SUBJECT: Response to Request for Additional Information Regarding Relief
Request No. RR-PR-01
Vermont Yankee Nuclear Power Station
Docket No. 50-271
License No. DPR-28

Vermont Yankee Nuclear Power Station
Response to Request for Additional Information

**REQUEST FOR ADDITIONAL INFORMATION FOR
RELIEF REQUEST NO. RR-PR-01
RELATED TO TESTING OF SERVICE WATER PUMPS
ENTERGY NUCLEAR OPERATIONS. INC.
VERMONT YANKEE NUCLEAR POWER STATION
DOCKET NO. 50-271**

Inservice Test Data

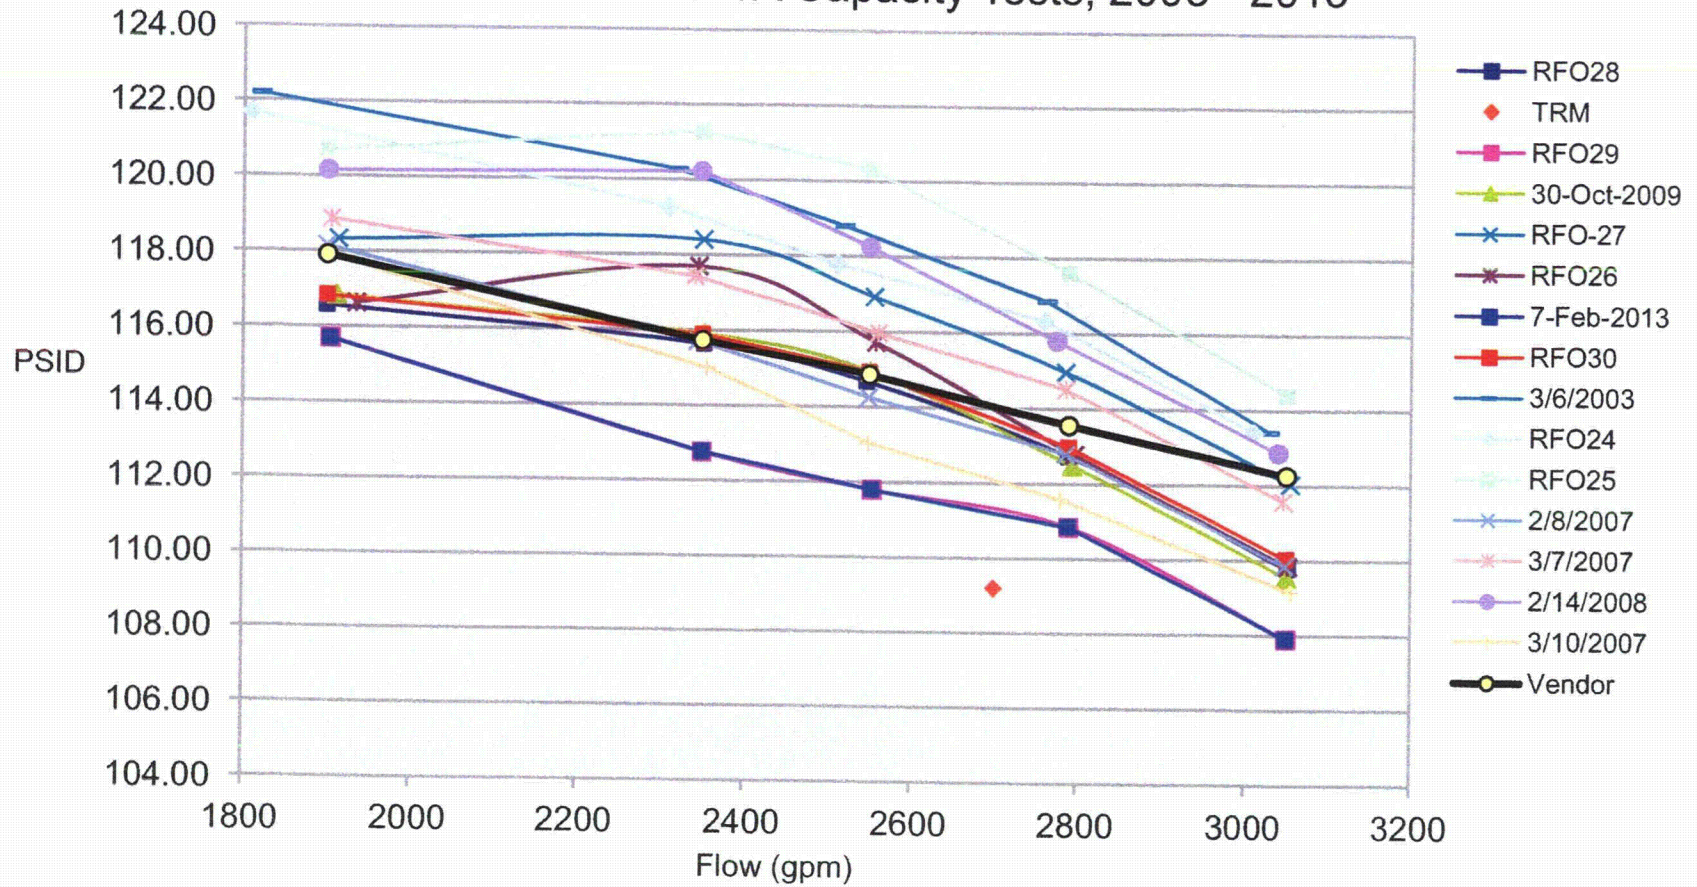
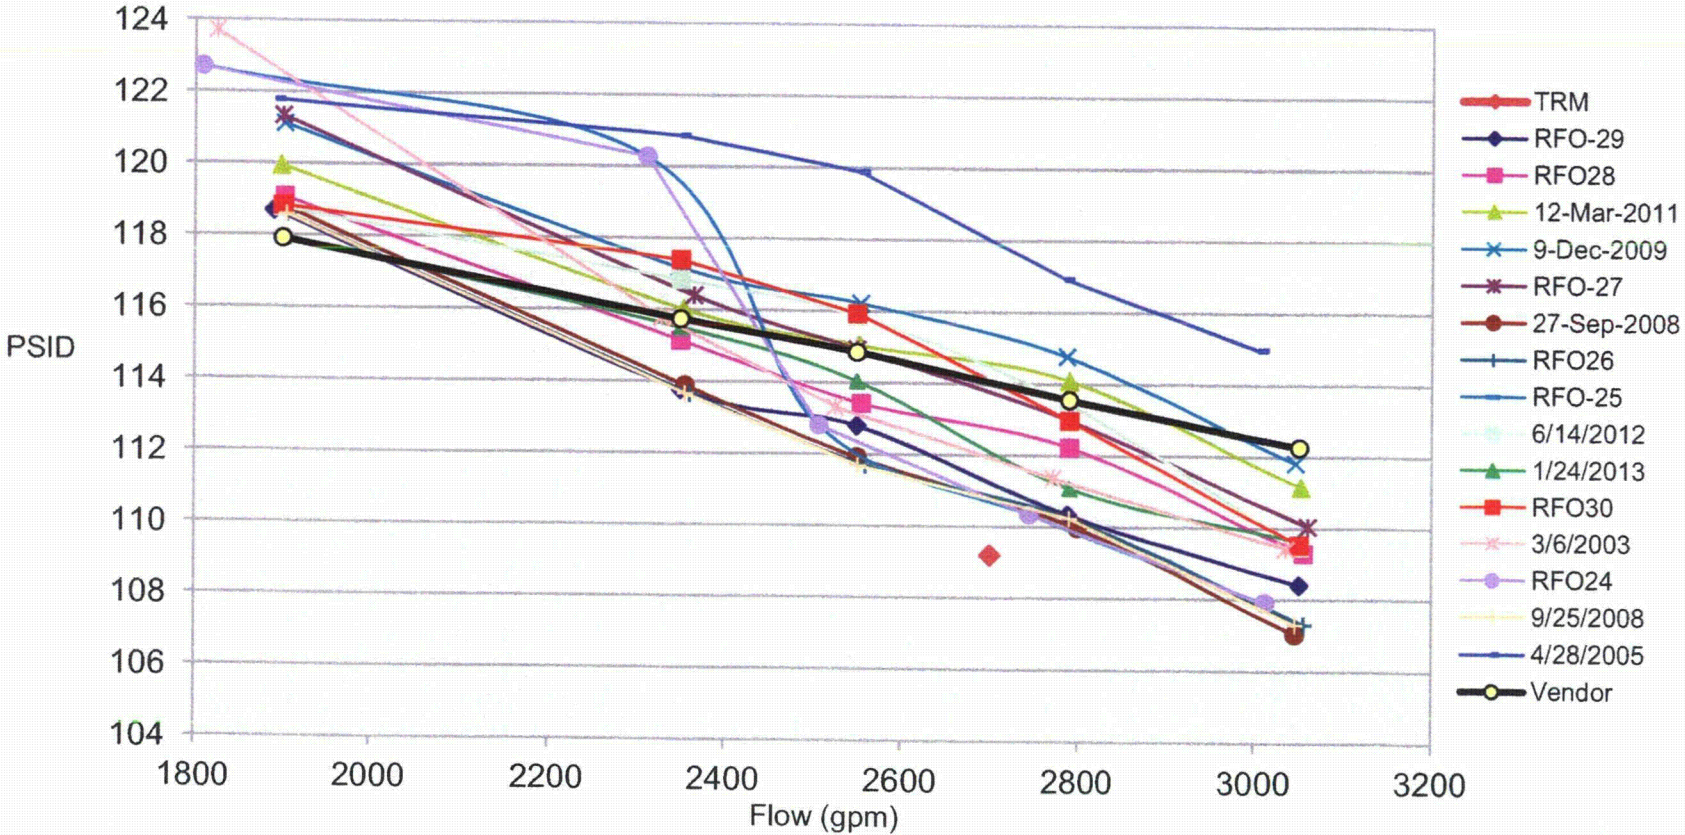
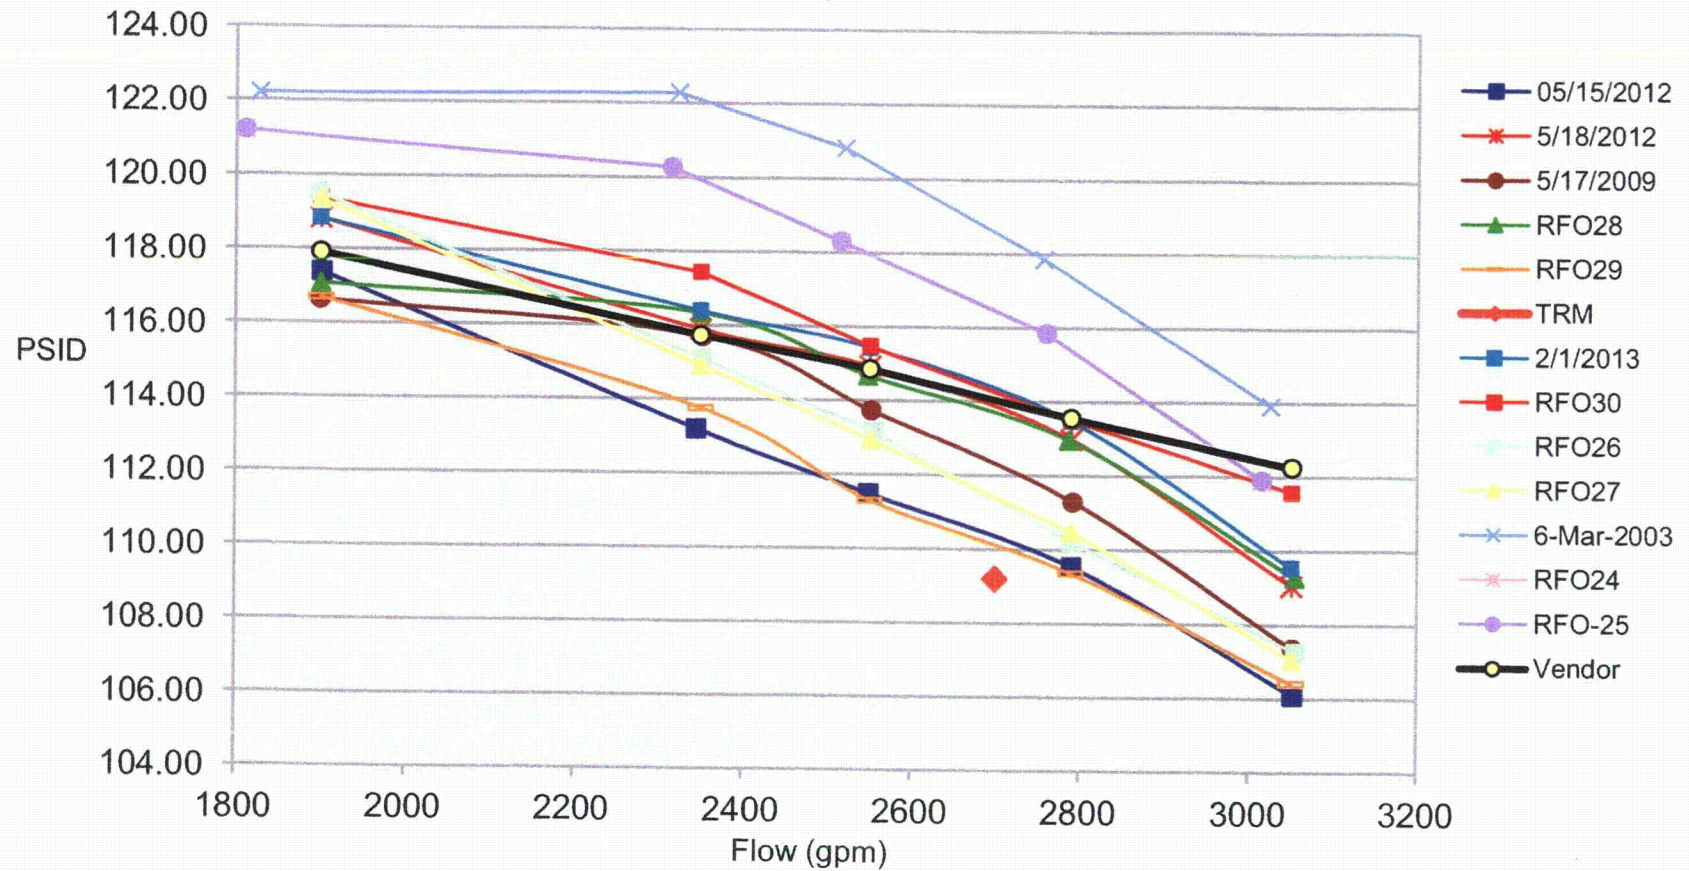
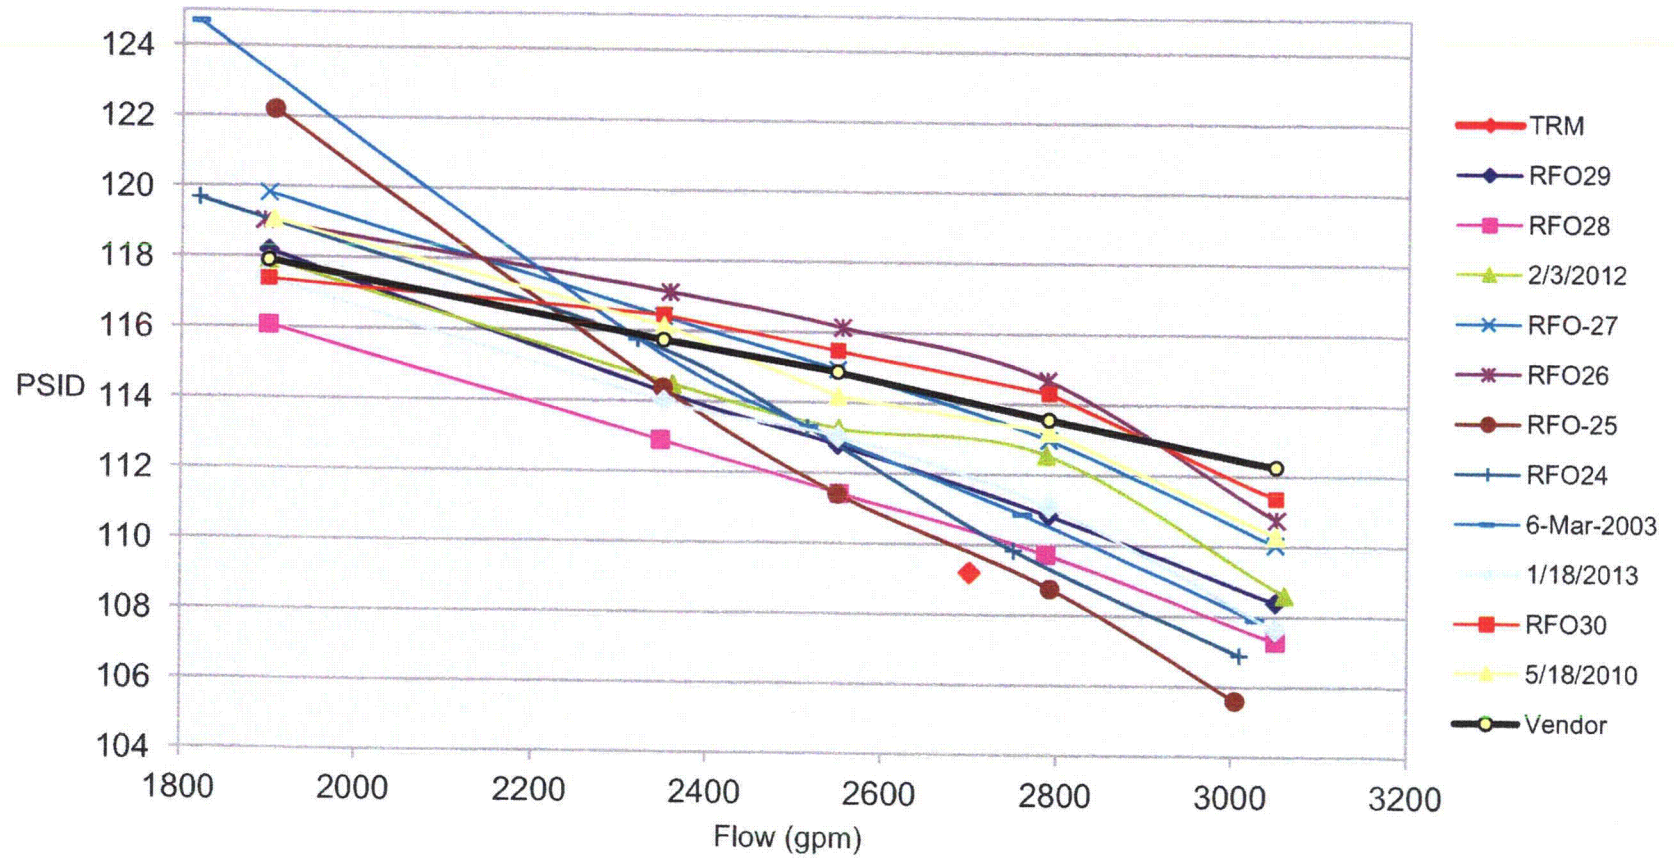
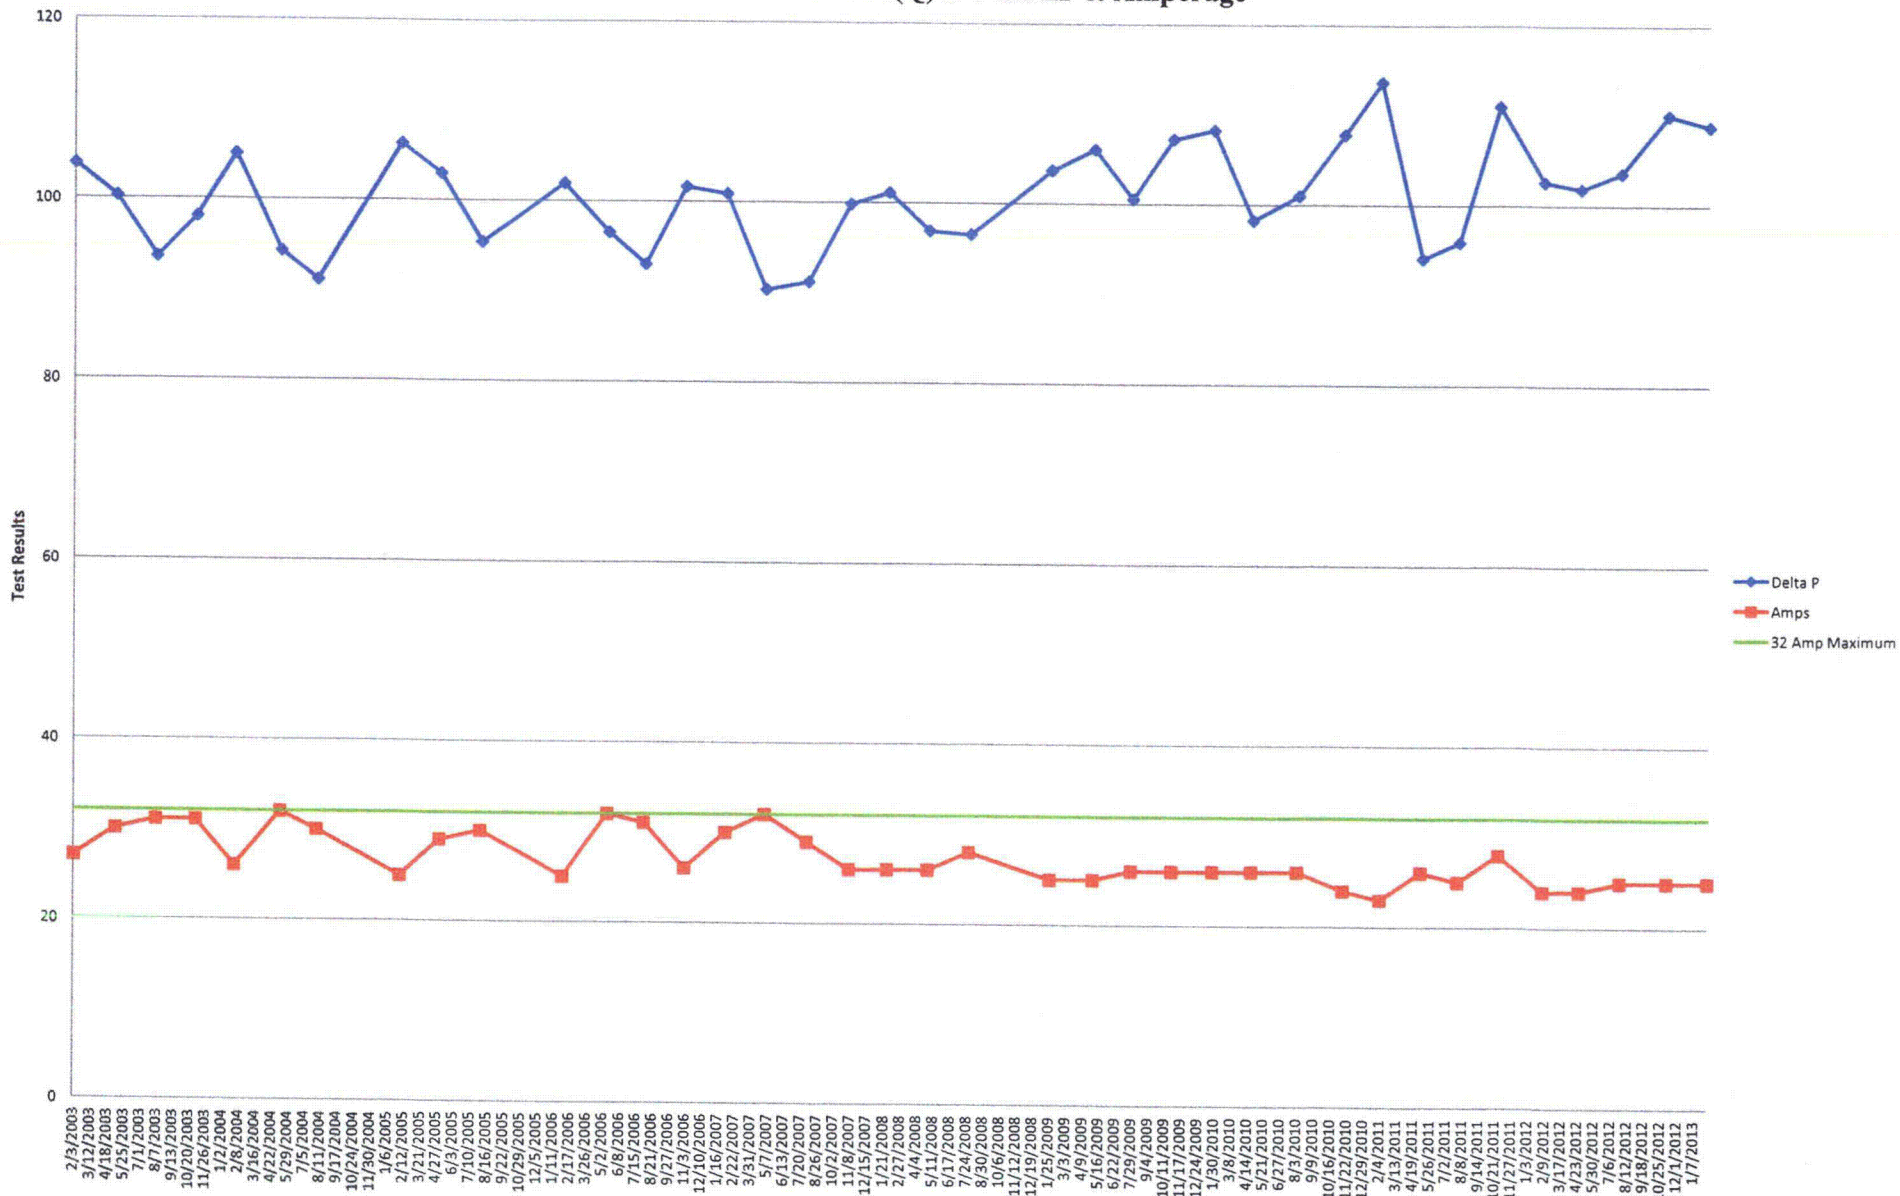
Please provide the inservice test data for the past 10 years for all of the service water pumps noted in this request.

The inservice test (IST) 5-point (capacity) test, quarterly d/p and amperage test, and quarterly pump vibration test data for the past 10 years for all of the Service Water pumps noted in the relief request are included in Attachment 2. Note that vibration data, which is taken at all 5 points during the 5-point test, is not included in capacity test results due to the volume of data.

1. Vibration test data is in units of inches per second. The .325"/sec. is generic OM Code Alert maximum, however point A-1 is approx. ½ of maximum.
2. The quarterly test data is from the IST trend database (original data transferred from completed test forms).
3. The 5-point test data is from the IST "set-up" validation spreadsheet (official data is contained in the completed test form). This data includes the scheduled RFO surveillance and lift adjustments.
